# **SERVICE LETTER 261**

## WIRE TERMINAL BLOCK REPLACEMENT

Aircraft Makes/Model(s):	Float Model(s):	Compliance: Optional	By: MAS
Textron Aviation 208, 208B, Air Tractor AT-802 & AT-802A, 8750A, 10000A, & 13000A	Part Number: 1012490	Approved: DRH	
DeHavilland DHC-6	57 557 K, 15 555 K, & 15 555 K	Date: 1/23/2024	Revision: A

8750A Float Model

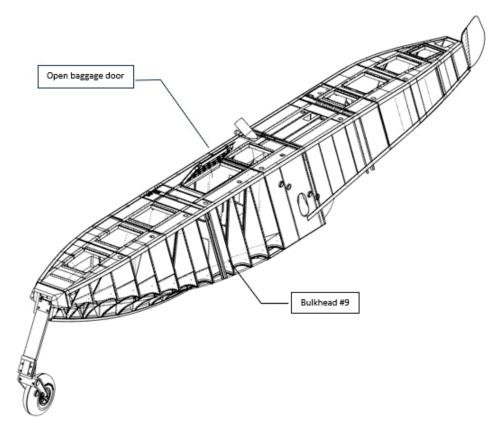
- 1. Position and prepare aircraft for safe maintenance.
- 2. Disconnect aircraft battery.
- 3. Locate the existing wiring terminal. For 8750, the terminal is in the aft baggage compartment on bulkhead #9. For 10,000 series, the terminal is on the forward bulkhead in the baggage compartment, bulkhead #9. The terminal block on the 13000 series float is in the front baggage compartment on bulkhead #6.

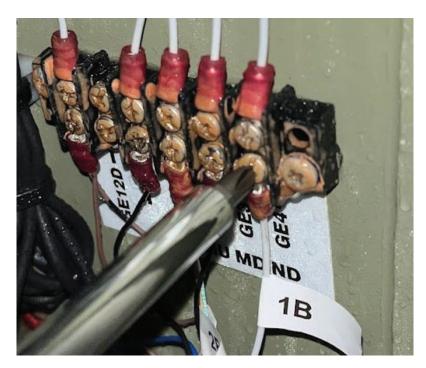
4. Mark or label each wire pairing so when wires are reinstalled, the correct wire pairs are installed together.

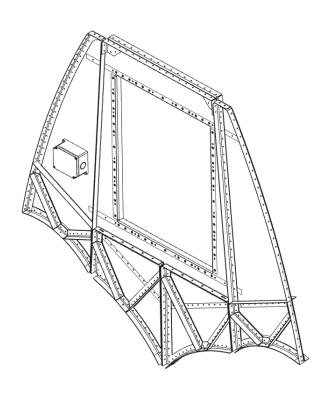
6. Prepare the new terminal block by drilling out and deburring the knock-out holes, then installing the cable glands. Ensure the seal on cable gland is between the exterior housing and nut. Tighten both nuts with a wrench.

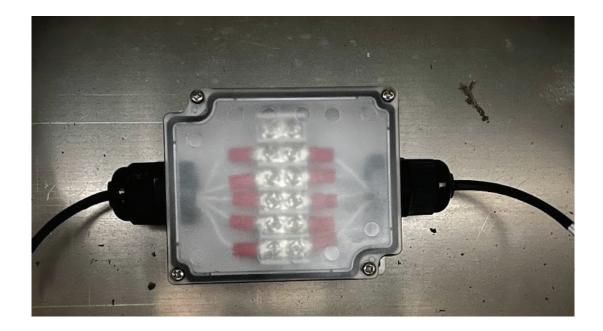
16. Secure each wire pairing to the new terminal block in the housing. Place corrosionX or equivalent compound on the terminal junctions.
